KNOXVILLE/KNOX COUNTY METROPOLITAN PLANNING COMMISSION SUBDIVISION REPORT - CONCEPT/USE ON REVIEW

► FILE #: 2-SH-07-C 2-H-07-UR	AGENDA ITEM #: 28 AGENDA DATE: 2/8/2007				
SUBDIVISION:	HAMPTON COURT				
APPLICANT/DEVELOPER:	EAGLE BEND REALTY				
OWNER(S):	EAGLE BEND REALTY				
TAX IDENTIFICATION:	118 116 & 116.02				
JURISDICTION:	County Commission District 5				
► LOCATION:	West side of Bob Kirby Rd., north of Dutchtown Rd.				
SECTOR PLAN:	Northwest County				
GROWTH POLICY PLAN:	Planned Growth Area				
► APPROXIMATE ACREAGE:	10.09 acres				
ZONING:	PR (Planned Residential)				
EXISTING LAND USE:	Residence and vacant land				
PROPOSED USE:	Detached residential subdivision				
SURROUNDING LAND USE AND ZONING:	North: Residences / PR (Planned Residential) South: Residences / A (Agricultural) East: Residences / RA (Low Density Residential) West: Residences / RA (Low Density Residential)				
NUMBER OF LOTS:	45				
SURVEYOR/ENGINEER:	Jim Sullivan				
ACCESSIBILITY:	Access is via Bob Kirby Rd., a minor collector street with 21' of pavement width within 60' of right of way.

Agenda Item 28

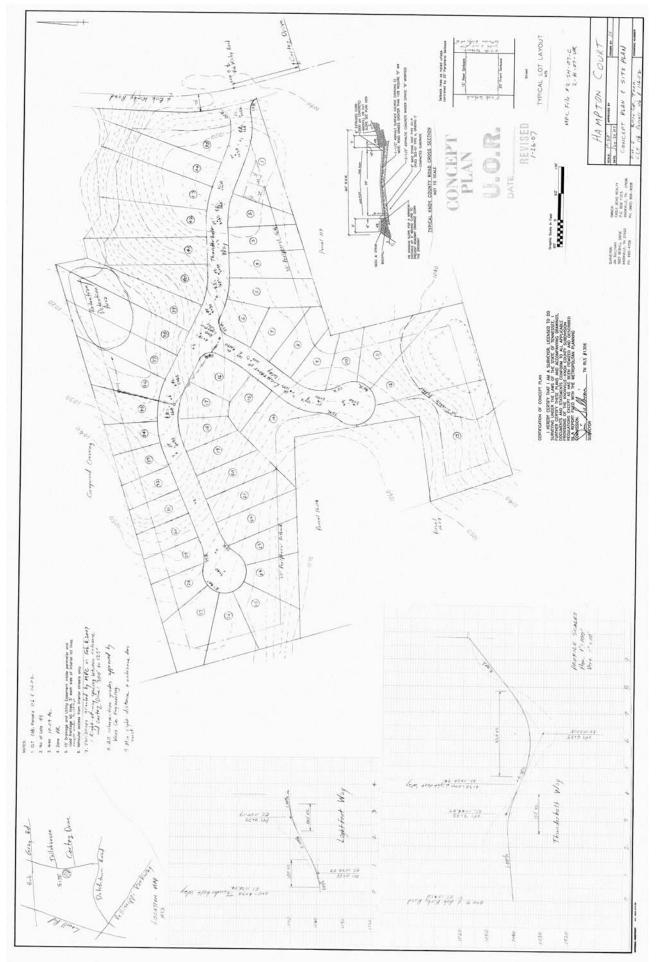
SUBDIVISION VARIANCES REQUIRED:	 Intersection spacing variance from the proposed entrance to Cortez Drive, from 300' to 130'. Intersection spacing variance from the proposed entrance to Tallahassee Drive, from 300' to 280'.

APPROVE variances 1 and 2 because the property's location restricts compliance with the Subdivision Regulations, and the proposed variances will not create a traffic hazard.

APPROVE the Concept Plan subject to 9 conditions:

3. Placing a note on the final plat that all structures will have to be located at least 50' from the top of the sinkhole (closed contour area) identified on the plat in the area of Lot 27. Construction within the 50' setback

may be permitted if a geotechnical study prepared by a registered engineer states that building within the 50' sinkhole buffer is acceptable and the study is approved by the Knox County Department of Engineering and Public Works. Construction is not permitted within the hatchered contour area of the sinkhole. Engineered footings may be required for any structures within the 50' sinkhole buffer. If a determination is made by the Tennessee Department of Environment and Conservation that this feature is not a sinkhole, this condition would not apply.

There is a hatchered contour area designated on the KGIS database in the area of proposed Lots 12 and 13. The sinkhole and 50' building setback from the top of the sinkhole (closed contour area) shall be designated or the final plat. All lots in the area of the sinkhole must have a suitable building area outside of the setback area. An option would be to have a geotechnical study conducted by a registered engineer that would identify that building within the 50' sinkhole buffer is acceptable, and the study is approved by the Knox County Department of Engineering and Public Works. Engineered footings may be required for any structures within the 50' sinkhole buffer. If a determination is made by the Tennessee Department of Environment and Conservation that this feature is not a sinkhole, this condition would not apply.
